# Service Bulletin

**Subject:** Service StabiliTrak Message Displayed, DTC C0196-5A Set in Electronic Brake Control Module (EBCM)

**Models:** 2015-2016 Cadillac Escalade Models  
2014 Chevrolet Silverado 1500  
2015-2016 Chevrolet Silverado, Suburban, Tahoe  
2014 GMC Sierra 1500  
2015-2016 GMC Sierra, Yukon Models

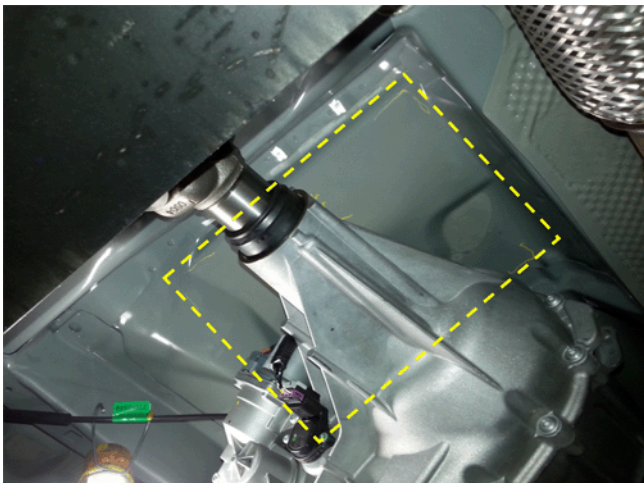
C0196-5A is related to YAW sensor plausibility. Engineering has determined that stone impacts to the underside of the transmission tunnel, right below the SDM, may cause the YAW/Lat sensor located in the SDM to send signal spikes related to the resonant frequencies of the sheet metal; 12-14 kHz range. If the YAW/Lat signals don't line up with vehicle speed and steering angle sensor data, the EBCM will set C0196-5A, plausibility fault. Sometimes the SDM will set C0196-00, invalid yaw rate data fault, if the stone impingement crosses the internal sensor fault threshold while will in turn cause the EBCM to set a C0452-71.

After completing necessary repairs to address the DTCs, perform the following procedure. Applying vibration deadening material to the underside of the transmission tunnel is intended to dampen the frequency of stone impacts to prevent a repeat occurrence.

2. Locate area shown above transmission and transfer case, if equipped.
3. Ensure the area is free of any debris by cleaning the area with wax and grease remover or equivalent. Ensure area is dry.
4. Mark the transmission tunnel as noted.

5. Wrap and tape off transmission, transfer case, propeller shaft, cables, wiring, exhaust, etc. to protect from overspray as illustrated above.

6. Apply vibration deadening/damping material specified to the marked area following manufacturer's guidelines.
